January 28, 1985

SUBJECT: Limerick Generating Station, Units 1 and 2, Organizational Changes
in the PECO Electric Production Department

Attached are draft changes to FSAR Section 17.2, Figures 17.2-2, 3, 4, 5, & 15 and related 260 Series questions which describe the subject changes. These changes have been reviewed and it has been determined that the changes do not reduce the commitments in the QA Program previously approved by the NRC.

FIGURE 17.2-15

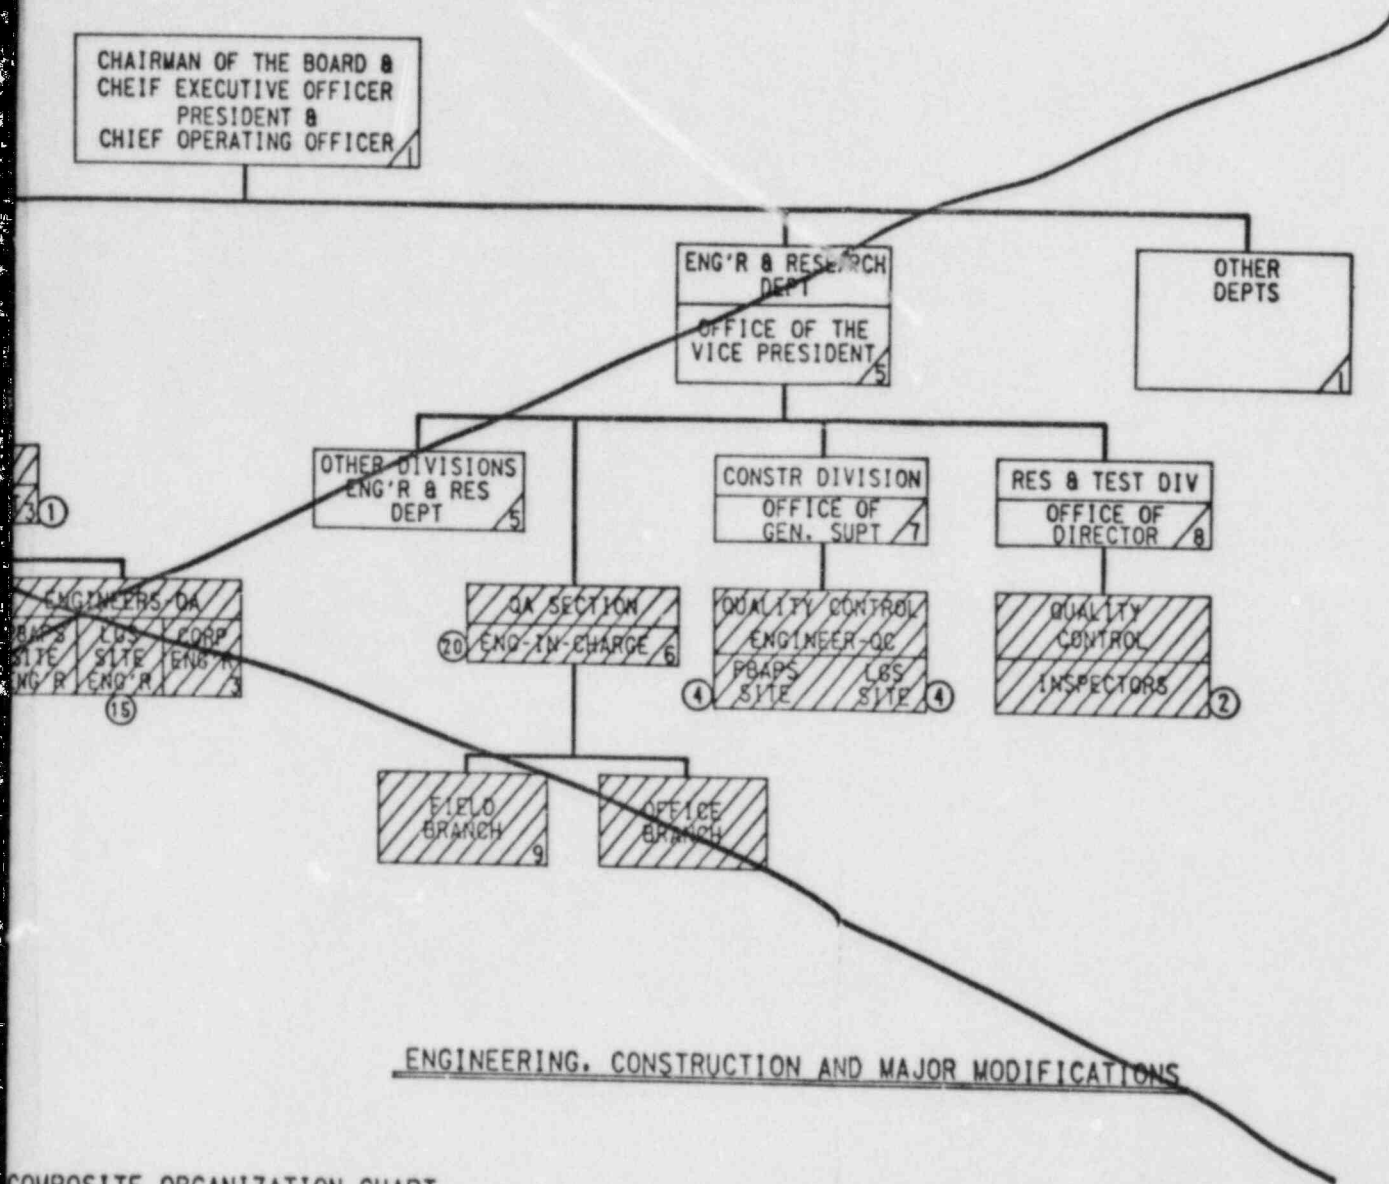
Figure 17.2-15 is a functional QA/QC Diagram of organizations performing within the Electric Production Department and the Engineering and Research Department, and its

~~Figure 17.2-15~~ outlines the approximate personnel staffing for QA/QC organizations involved in Peach Bottom and Limerick Stations.
